City of Cranston

City Plan Commission

Aug 4, 2020

Marcia B. Smith & Marvin M. Smith (OWNER), WINES AND MORE of RI, INC (APPLICANT)

EXISTING SIGN

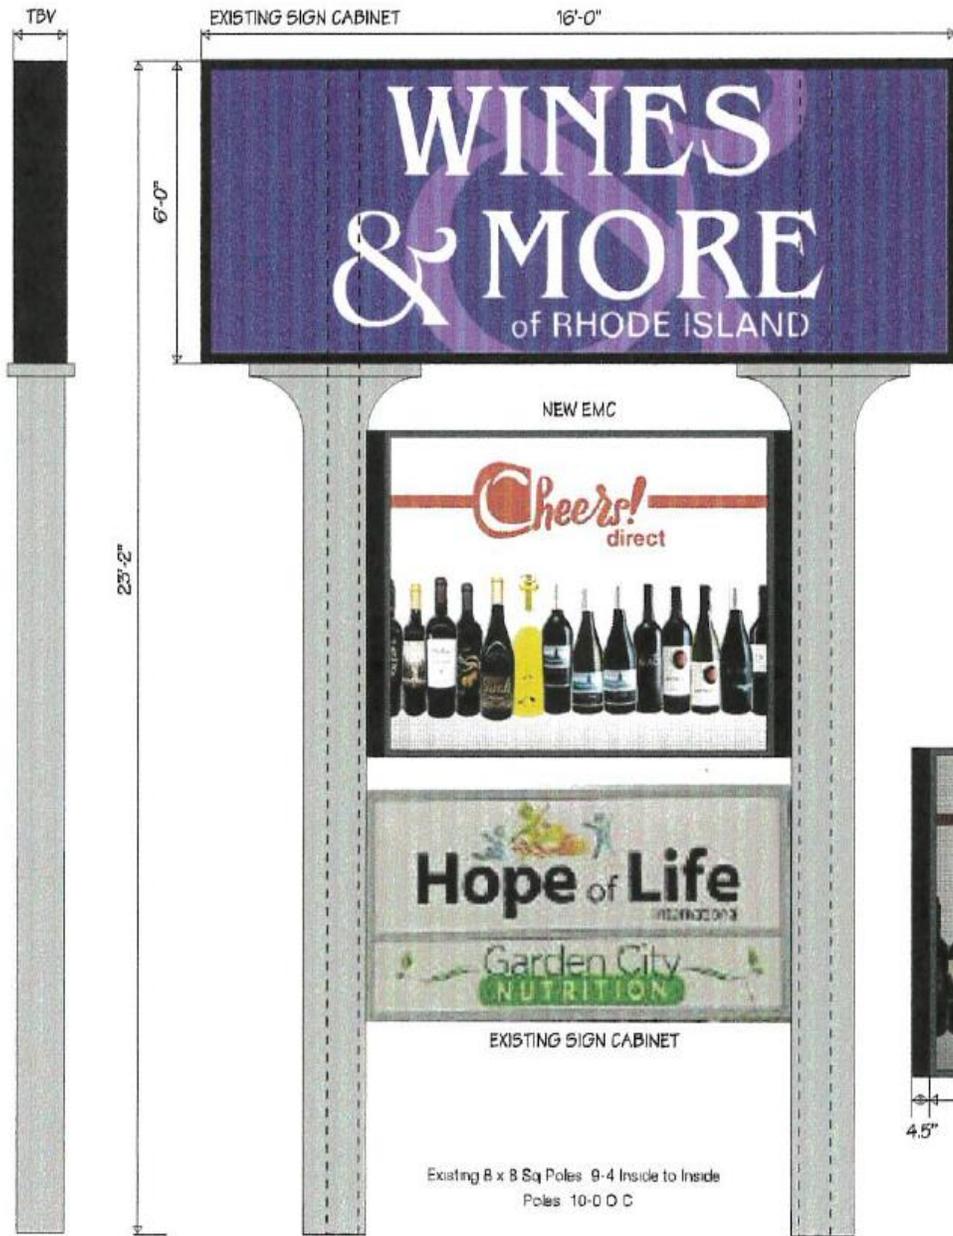
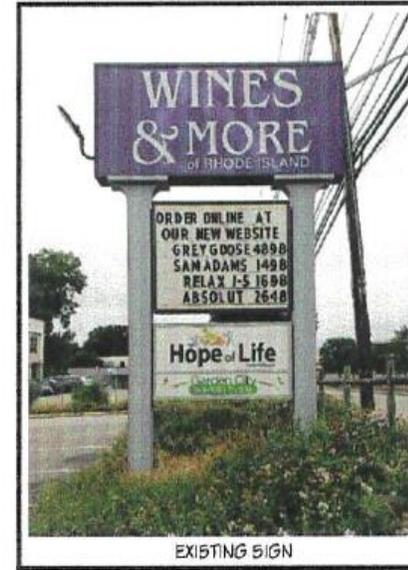
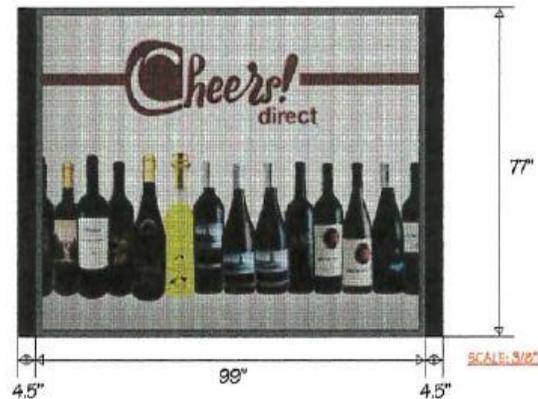
- The proposal does not increase the height or area of existing signage on the site, which the ZBR granted relief for in 2009.
- There are at least 3 other examples of animated signs on Sockanosset Crossroad alone, so relief would not be out of character with the area.

- Regarding animation and timing of images on the message board, the applicant clarified that *“the petitioner is requesting that a variance be granted to permit the digital sign to change every twenty (20) seconds to delineate products and items for sale at the establishment.”*

- Regarding brightness of the sign, the applicant has corresponded that *“the electronic message centers have automatic dimming capabilities and Watchfire Electronic message centers are equipped with a photocell that detects ambient light and adjusts brightness levels accordingly.”*

- Staff holds that if the City chooses to allow changeable copy signs, that allowing them to be upgraded to animated signs (with restrictions) would be reasonable.

- Relief, if granted, would not undermine the intent of zoning or the Comprehensive Plan.

Due to the findings that the proposal is consistent with the Comprehensive Plan and the character of the commercial area, and due to the assertion that businesses should be allowed to have animated signs instead of changeable copy signs (with restrictions), the Planning Department recommends that the Plan Commission forward a **positive recommendation** on this application to the Zoning Board of review, with restrictions to the sign's luminescence, animation, and frame change timing.
